June 5, 2013

**Re: Construction Storm Water Inspection at Knightsbridge MOB / Franklin County
Permit Number: 4GC04000 *AG**

Figure 1: Please maintain silt fencing to ensure proper function.

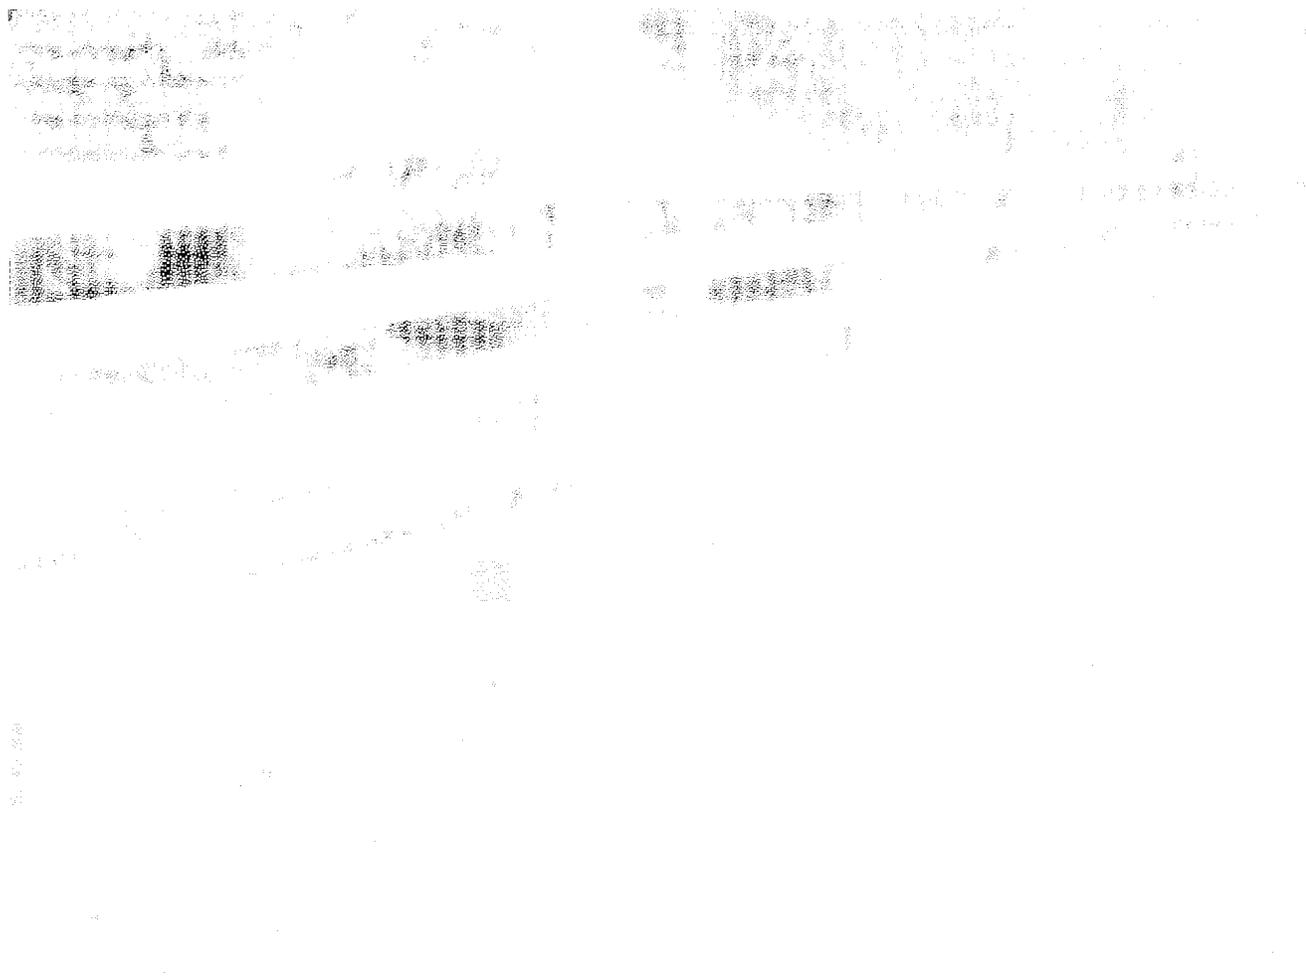
- Please maintain silt fencing on site edges to ensure proper functioning conditions (See Figure 1).
- Be aware the General Permit states that all barren areas which remain idle in excess of 21 days must be protected from erosion within seven days of the last earth disturbing activities. In addition, erosion protection must be implemented for all areas of final grade within seven (7) days.
